**ADDENDUM NO. 2**

**TOWN OF INDIAN HEAD, MARYLAND**

**TRAILHEAD RESTROOM  
SHA No. CH257B51  
FAP No. AC-TAP-3(871)E**

### 3.04 PLUMBING FIXTURE INSTALLATION

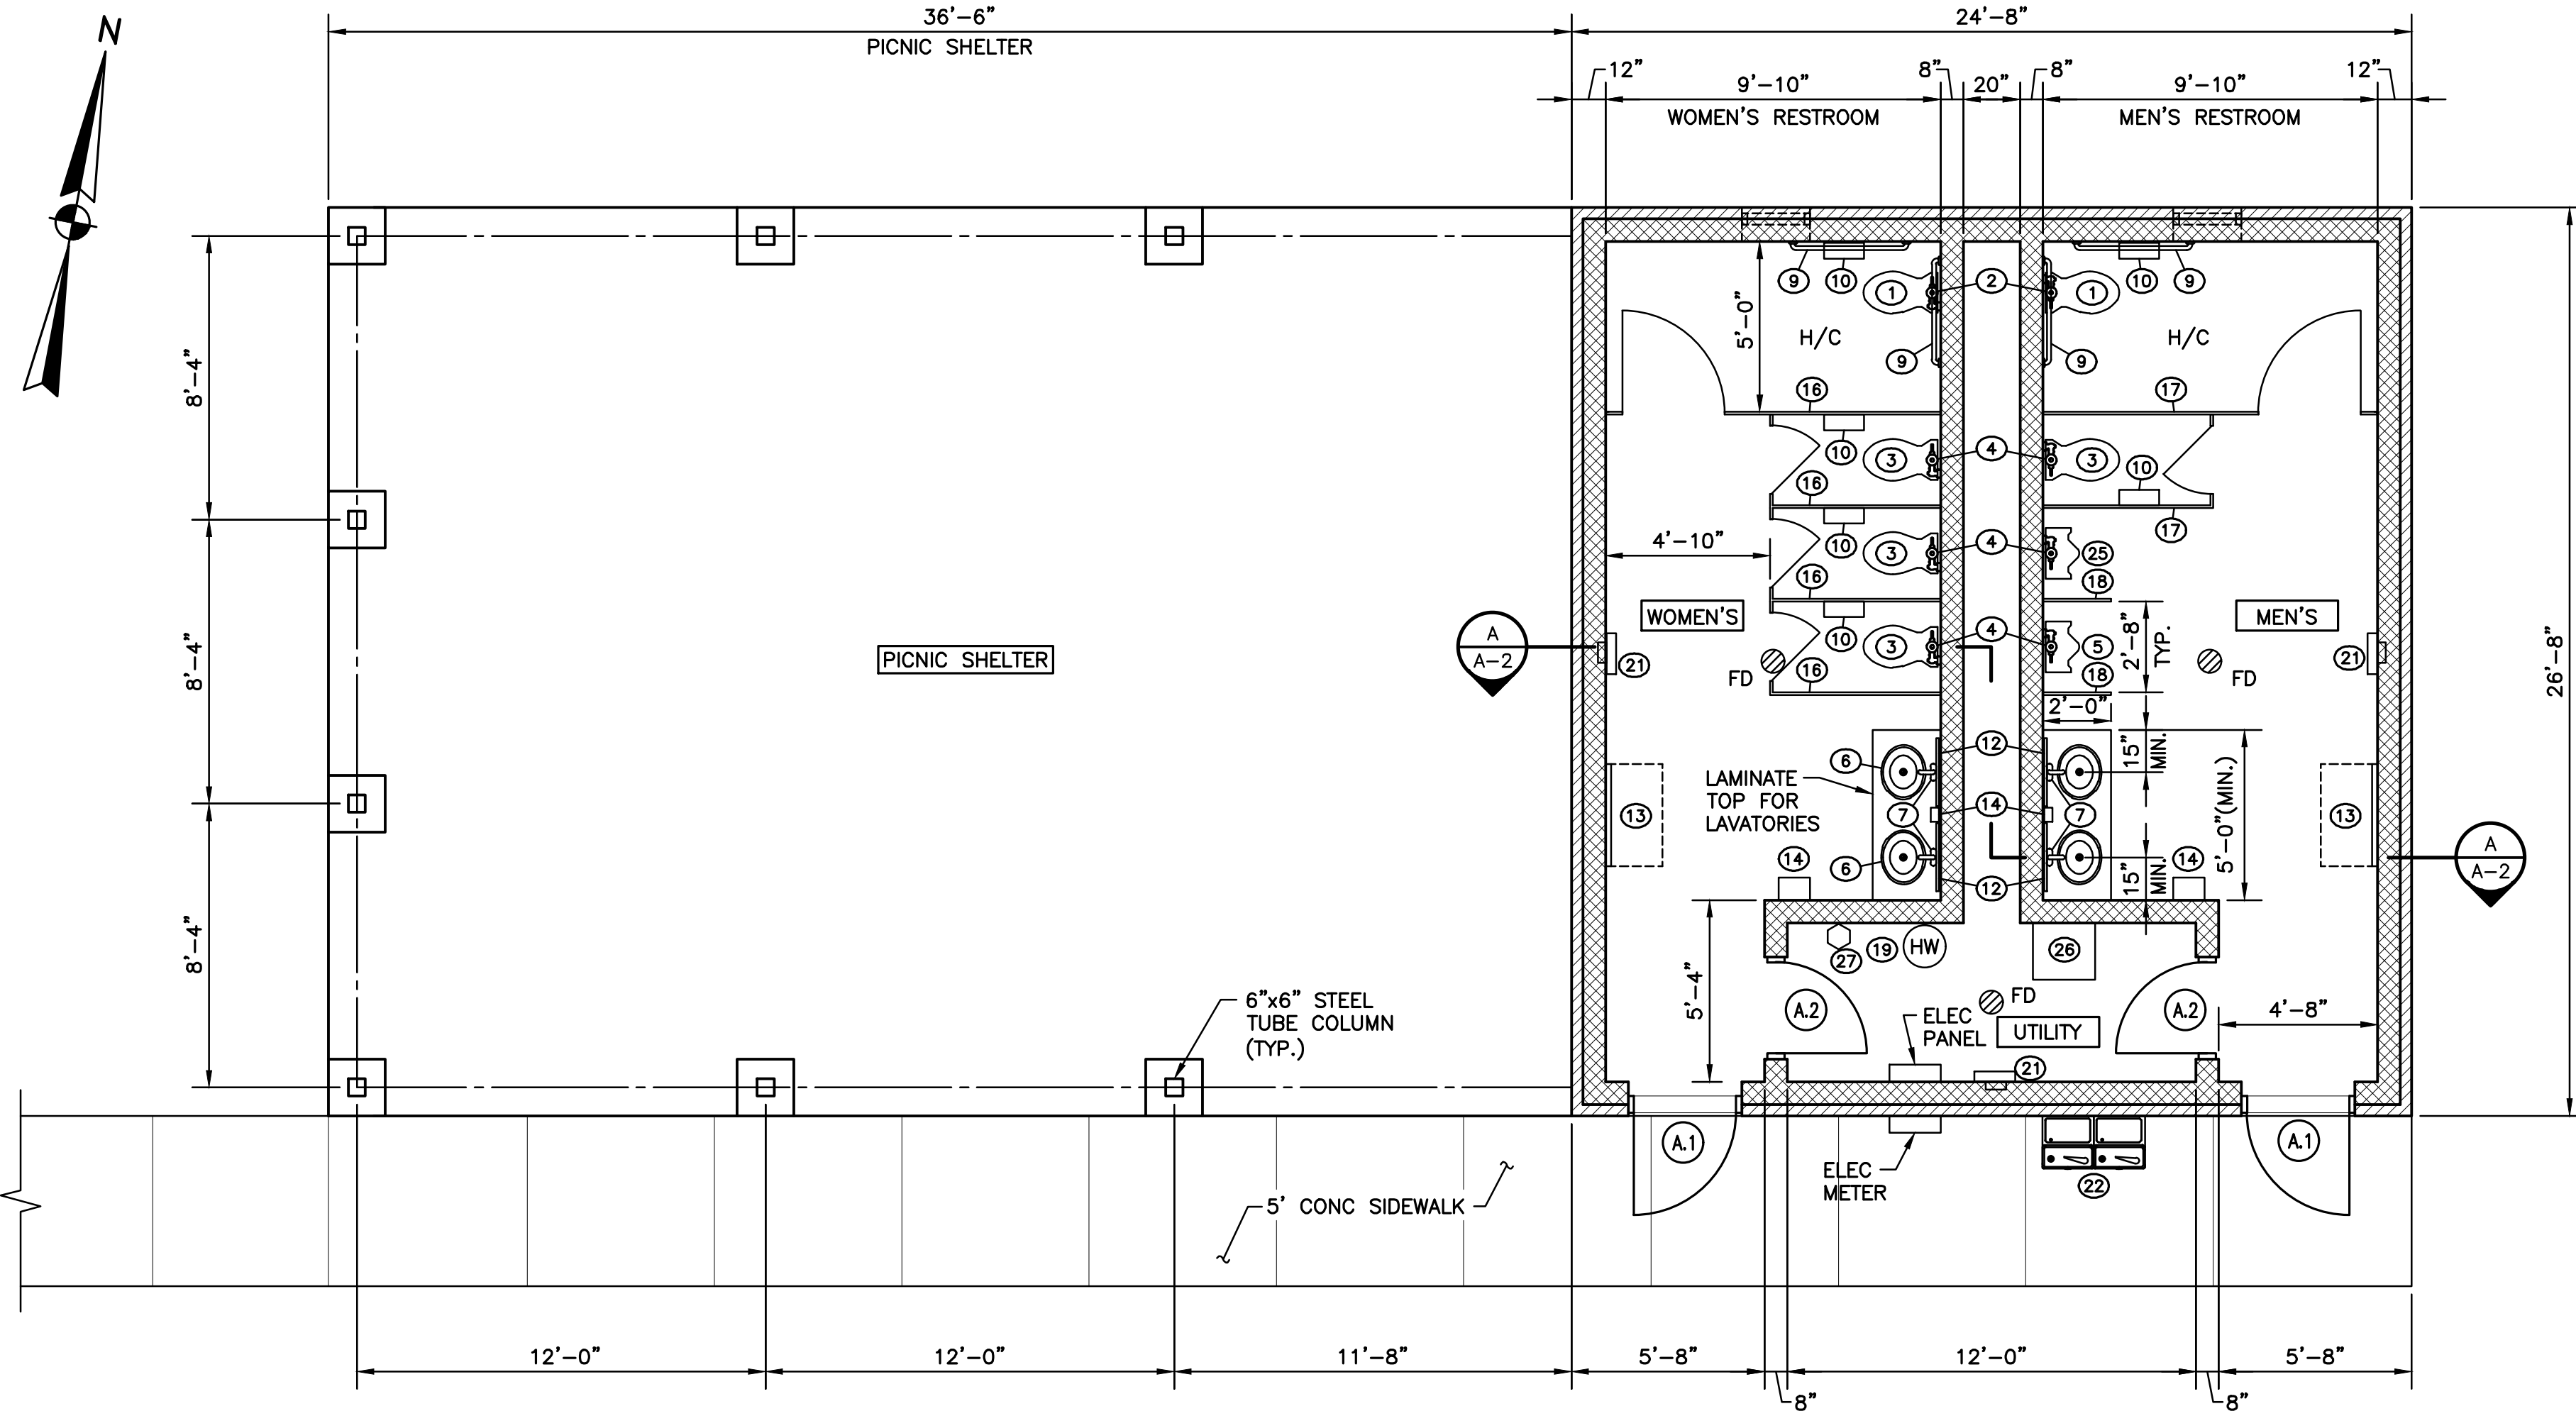
Question 5. The elevation of the louvers is unclear. If we course the block it appears the intake louvers is both above and below the ACT and the exhaust are shown at an elevation above the bottom of the trusses.

**Response: The bottom of exhaust louvers shall be placed at 10’-0”. Please see ‘Concerning the Drawings’ for an updated plan and detail.**

**SECTION A-A**  
SCALE: 1/4" = 1'-0"

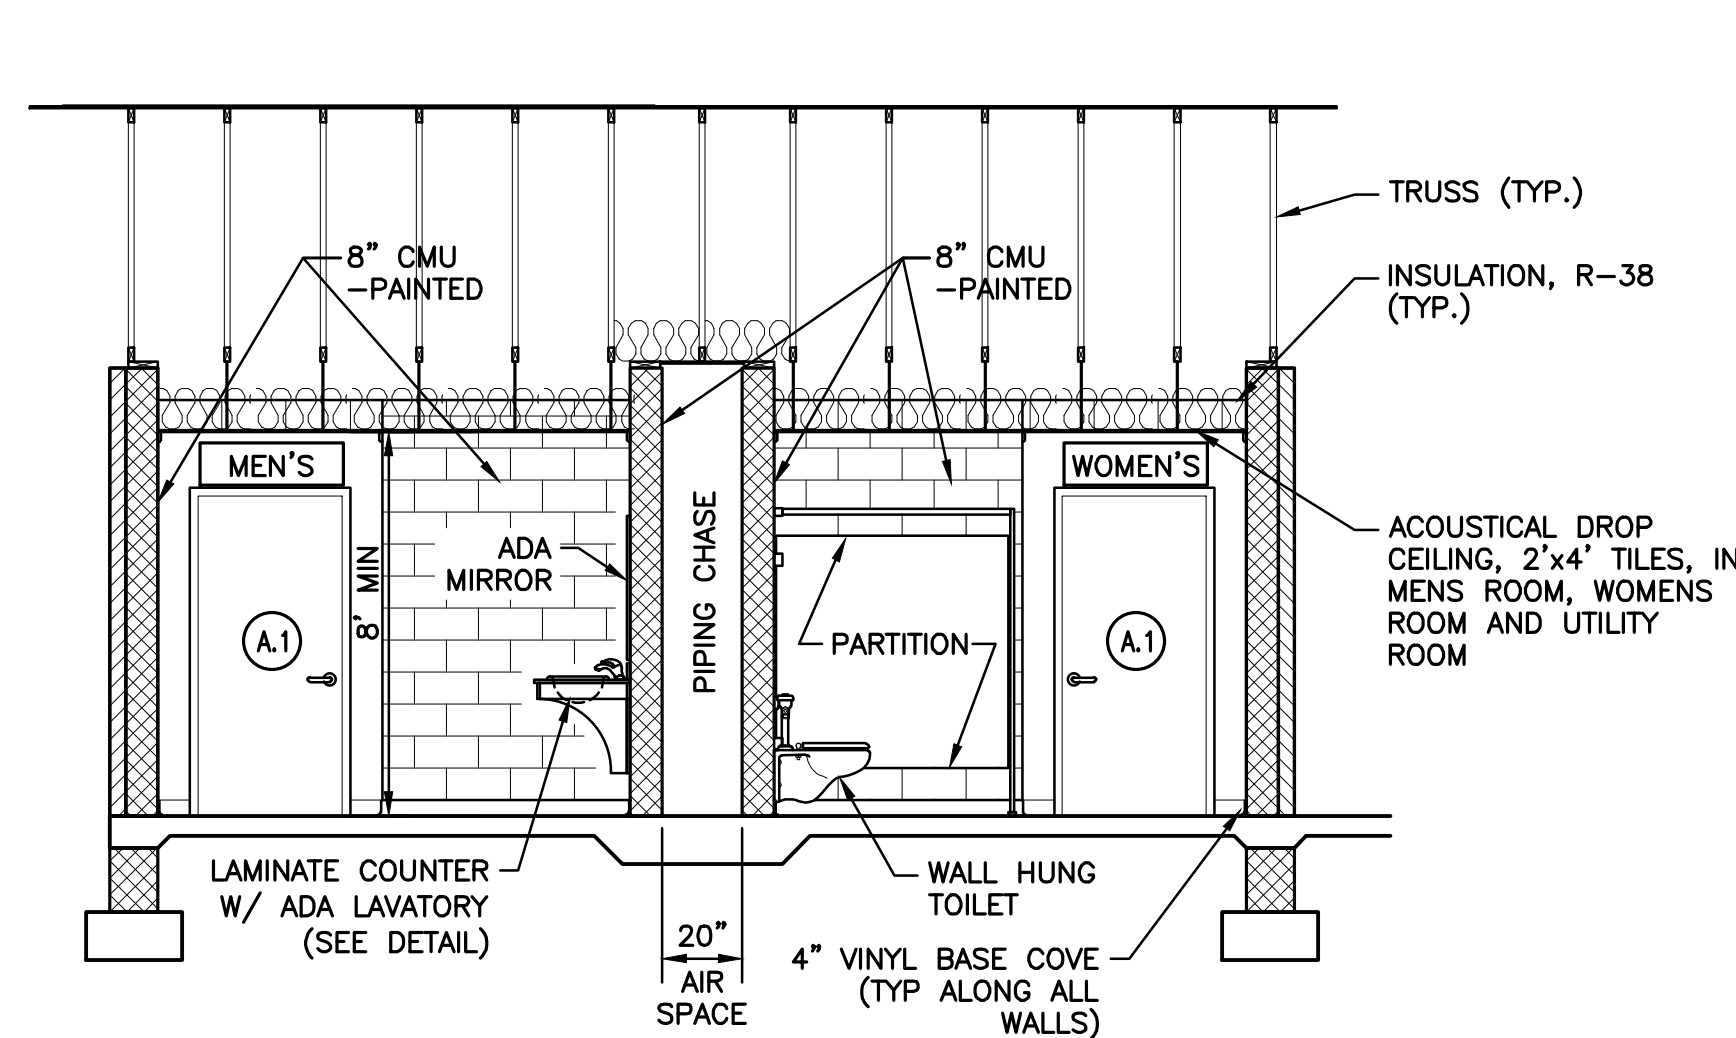
Question 4. What is the elevation of the ceiling. There are varying elevations throughout the drawings. Should it be 8’-0” in order to accommodate the ductwork?

**Response: Yes. The elevation of the acoustical drop ceiling shall be 8’-0”.**
